TRAPPER MINING INC.

Re: Trapper Mining Inc., Permit No. C-1981-010

Permit Revision PR-11, Response to Adequacy Review No. 2

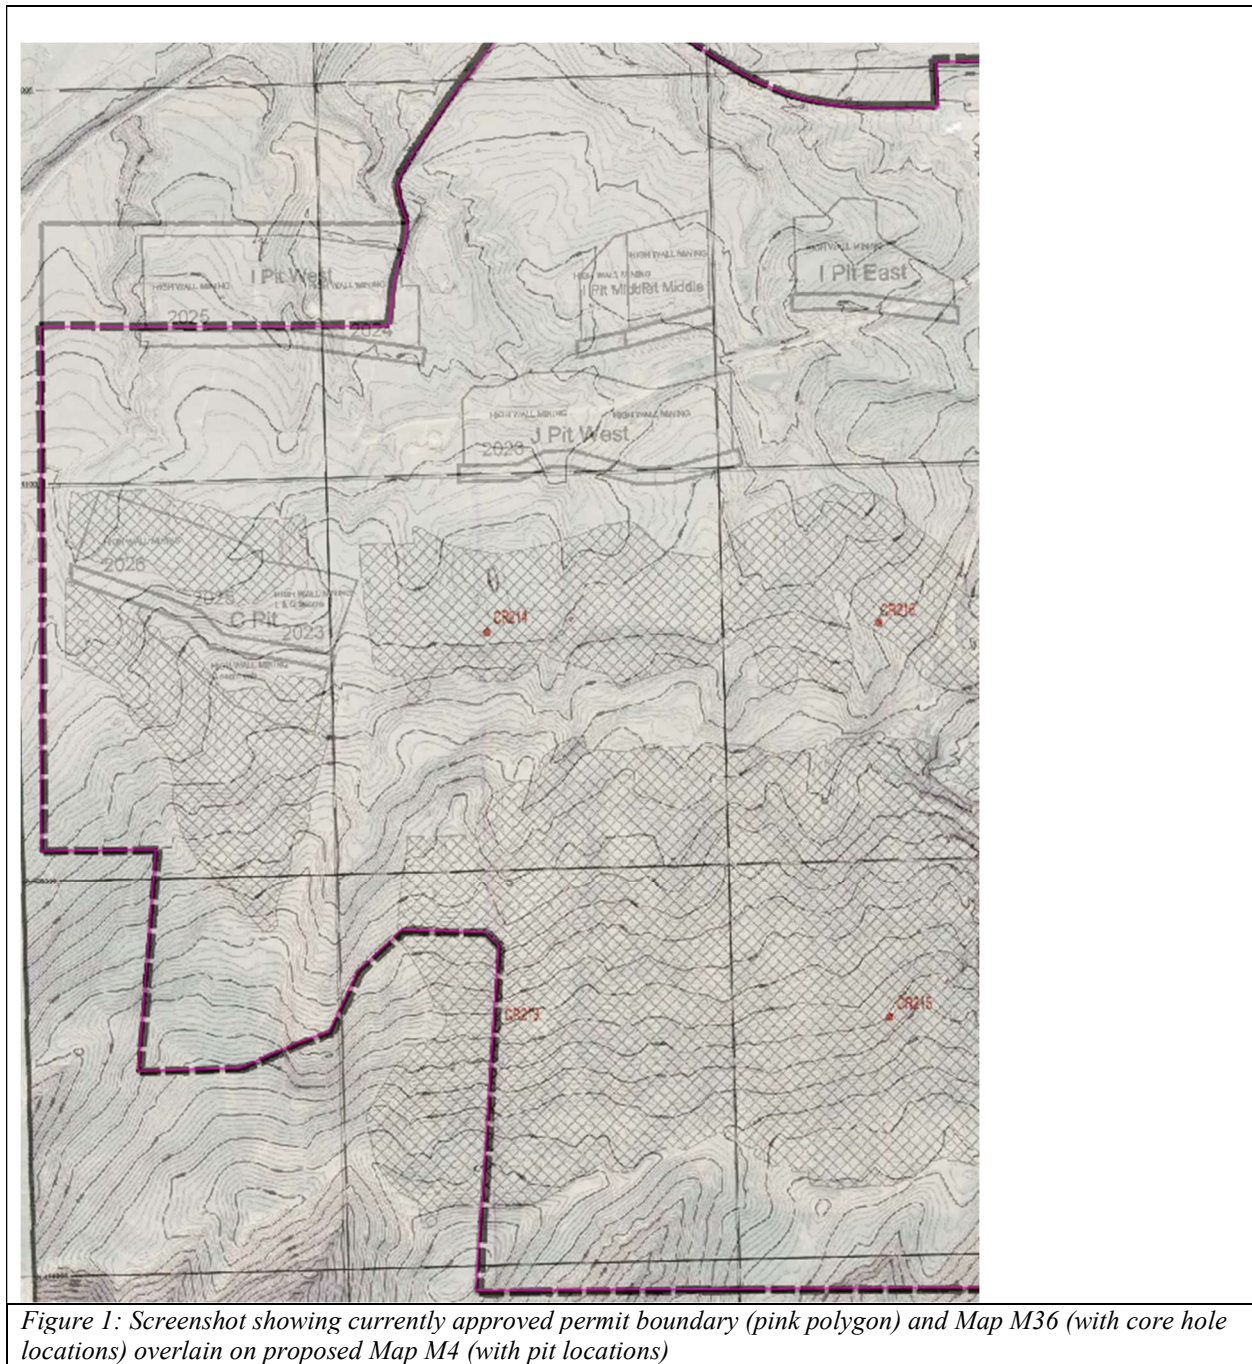
39. Map 36 shows the locations of core holes used to characterize overburden geochemistry, and Section 2.7.2 (Page 2-357) presents the results of the analysis. No revisions to Section 2.7.2 have been proposed with PR-11, and Map 36 shows that few core holes were drilled in the western part of the permit area (see Figure 1 below).

Please update Section 2.7.2 with a discussion of the characterization of overburden geochemistry for the C, I and J Pits.

Trapper Response to Comments 39: The Trapper minesite has been extensively cored over its four decades of operation. The core holes demonstrated on Figure 1 were drilled to the deepest coal seams to be mined as required in Rule 2.04.6(2)(b). Proposed mining in PR-11 is encompassed in the upper strata of the

Williams Fork formation. The entire minesite and its geology has been well documented. The rock stratigraphy encountered in the I and J pits is typical of the upper strata described in Permit Section 2.7.1.2. Current mining in the I and J Pits, situated at the crop area of their respective target coal seams, is encountering weathered to highly weathered sandstones and other associated depositional layers such as sands and gravels. Four new monitoring wells, CY-A, CY-1, CY-2 and CY-3, were drilled in response to these planned activities after the approval of PR-10. A fifth well was completed in 2022, GX-1, for monitoring of the C Pit. Their drill logs are incorporated into Appendix V of the PAP.

The C Pit area will be a long box cut situated immediately down dip of the previously mined C Pit, which was a down dip strip pit mined into the 1990's. A buffer of undisturbed bedrock will be left between the historic endwall and the new highwall. The previous and new C Pit will mine down to the Q seam. This area has been well documented and previously disturbed. No further analysis should be required in this area.

The apparent purpose of the geochemistry analysis of the overburden is to determine the suitability of the spoil materials for backfill stability and possible growth medium issues. Permit Section 2.7.2 discusses at length the sampling program conducted on Trapper Mine spoils. Appendix I contains the results of the overburden testing program. Spoil analysis concluded one possible area of concern, mid-slope, in the east panel of the mine site. The overburden profile contained small sections directly adjacent to certain coal seams that could have potentially contained high ESP values. Extensive subsequent testing revealed no spoil toxicity issues with ESP or any other regraded spoil parameter. During operations at the site, core hole analysis was eventually stopped in favor of systematic spoil sampling of the final regraded surface. In 2000, with the approval of TR-89, no further spoil sampling was deemed necessary as no issues in the surface spoil materials in the regrade had been found. Historic sample results are documented in Permit Section 2.7.2.3 for the PR-7 expansion of the permit boundary. The analysis in the permit, confirmed through extensive sampling, proved the mixing of the spoil materials during backfilling operations eliminates any undesirable chemical characteristics. Current and future mining of the I, J and C Pit areas will rely heavily on truck loader operations. This will extensively mix the materials upon backfilling. Trapper does not anticipate any undesirable spoil characteristics in these pit areas.

Given the above discussion, Trapper does not feel that Section 2.7.2 requires updating.

Figure 2: Screenshot showing currently approved permit boundary (pink polygon) overlain on currently approved Map M54G, with potentiometric surface of Third White Sandstone (red contour lines) and Second White Sandstone (green contour lines).

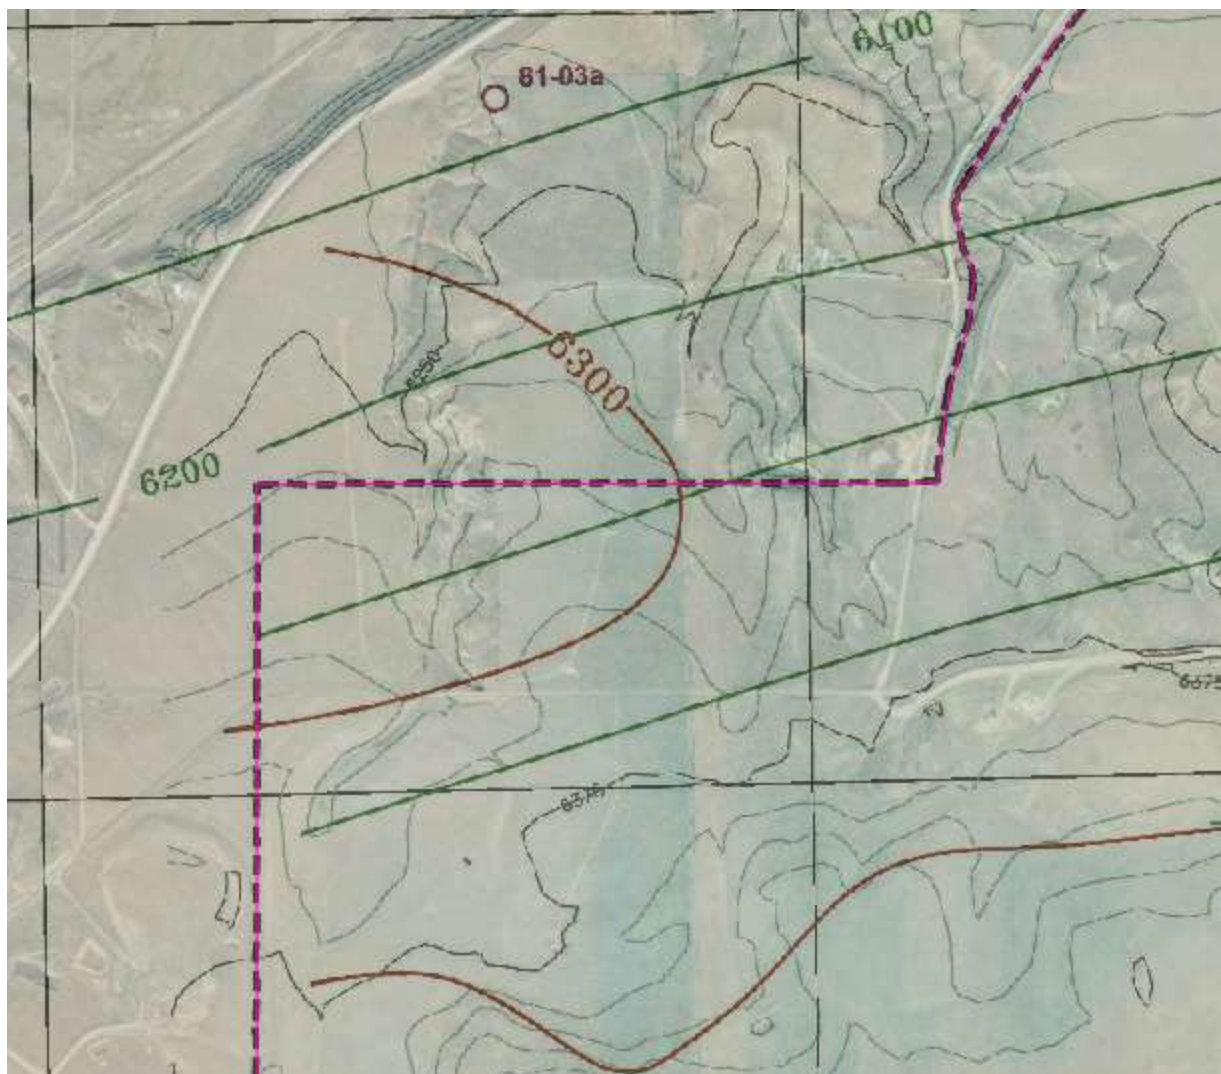
42. The water levels in the Twentymile Sandstone, Third White Sandstone, Second White Sandstone and Alluvial Aquifers are presented on Map 54G, which was last updated with PR-7 in 2014. The map shows projected contour lines at 100' intervals of the potentiometric surface in each of the named aquifers, from which the direction of groundwater flow can be inferred. The map suggests that groundwater flows generally to the NNW across most of the permit area in all three of the identified bedrock aquifers. There is an anomaly in the Third White Sandstone in the region of the PR-11 addition to the permit area (see Figure 2), where the 6300' contour line is shown curving dramatically around by 180°. If this line were accurate groundwater flow in the Third White Sandstone would be to the W, or possibly SW, beneath the proposed I Pit West, and neither of monitoring wells 81-03A or CY-3 would be downgradient of the proposed disturbance. Based on the information available in the PAP, the Division finds the projected potentiometric surface shown on the currently approved Map 54G implausible, particularly given that no such anomaly is shown in the Second White Sandstone which overlies it. According to Figure 2.7-4 (page 2-356) the axis of the synclinal basin is approximately 2 miles to the north, so there is no structural rationale.

Given that the Third White Sandstone is immediately below the G-seam (according to figure 2.7-18p, page 2462b), further characterization of this aquifer in the PR-11 area is warranted.

Characterization of the the alluvial aquifers in the three drainages in the west of the permit area appears to be lacking.

- (a) Please discuss the anomaly in the Third White Sandstone aquifer described above.**
- (b) Please update Map 54G with the most recent data available to show the best possible prediction of the potentiometric surface in each of the named aquifers. (It may be necessary to collect data from another point south and west of 81-03A and CY-3)**
- (c) Depending on the response to (a) and (b), please propose an additional downgradient monitoring well in the Third White Sandstone if necessary.**
- (d) Please discuss the characterization of the alluvial aquifers in the west of the permit area.**

Trapper Response to Comments 42:

(a) The water level elevations in the Third White Sandstone in the northwestern portion of the Trapper Mine are defined by the water levels in well 81-03A, CY-3 and GE-3 (prior to its abandonment in 2003). Water level elevations in wells CY-3 and GE-3 are lower than the water-level elevation in well 81-03A, indicating a depression in the piezometric surface to the south of well 81-03A. Water-level elevations in well CY-3 are higher than the water level elevation observed in well GE-3, indicating a gradient from the east to the west in this depression. This data indicates Third White Sandstone groundwater is flowing out of this aquifer to

the west in the area of the Yampa River alluvium. The geologic cross section to the west of the CY well locations shows the top of the Third White Sandstone very near the land surface (elevation of approximately 6250 ft-msl) in the Yampa Valley alluvial system to the west of the CY-3 well location. Therefore, the Third White Sandstone groundwater flow from the CY-3 area is expected to flow to the west to the Yampa alluvial groundwater.

(b) New maps M54I, M54J and M54K give projected potentiometric surface information for the QR aquifer, HI aquifer and FG aquifer, respectively.

(c) The CY-3 and 81-03A water levels, along with the historical water level, adequately define the groundwater flow in the Third White Sandstone aquifer in this area and shows that well CY-3 is an adequate downgradient monitoring well for the Third White Sandstone aquifer in this area.

(d) Permit Sections 2.7.7, 4.8.4 and Appendix H of the Trapper permit details the extent of alluvial aquifers and their possible impacts for the mine site. The only designated alluvial aquifers in the vicinity of the west panel were the Williams Fork and Yampa River floodplains. The Williams Fork river AVF will not be affected. The Yampa River AVF overlies the rock strata of the site in the Big Bottom Syncline. The mining disturbed strata dips deeply below this aquifer and was determined to be isolated from those aquifers. The smaller drainages in the I and J Pit areas do not contain significant enough alluvial deposits to create an aquifer.
